Table 3.2-9

INSTRUMENTATION WHICH INITIATES RECIRCULATION PUMP TRIP

TABLE 3.3.9.1.1

HATCH - UNIT 2

BASES FIGURE B 3/4 3-1  
REACTOR VESSEL WATER LEVEL

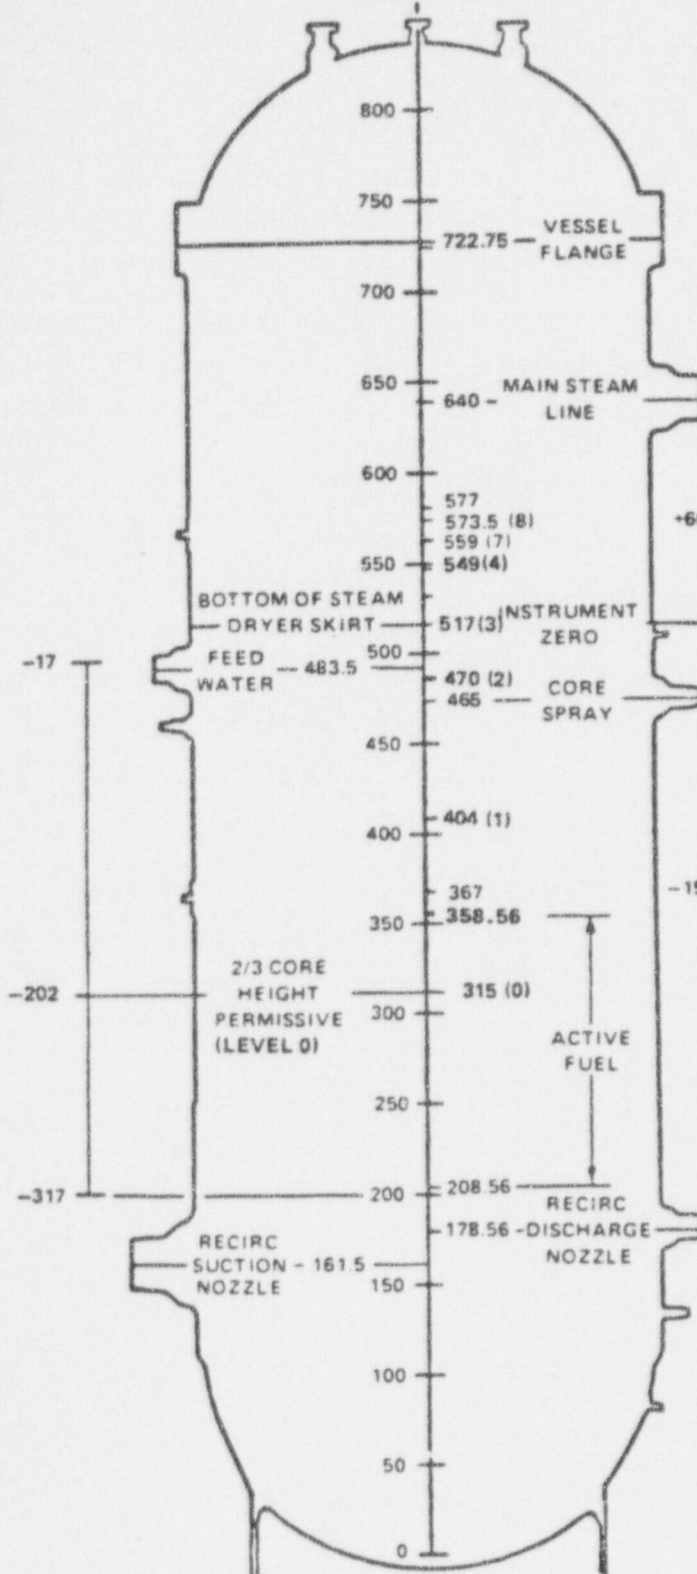
NO	(INCHES)	READING	INSTRUMENT
(8)	573.5	+56.5	BARTON/ROSEMOUNT
(7)	559	+42	GE/MAC
(4)	549	+32	GE/MAC
(1)	517	0.0	BARTON/ROSEMOUNT
(2)	470	- 47	BARTON/ROSEMOUNT
(1)	404	- 113	BARTON/ROSEMOUNT
(0)	315	-202	BARTON/ROSEMOUNT

\*Recirculation Pump Trip Analytical Limit is -58 inches.
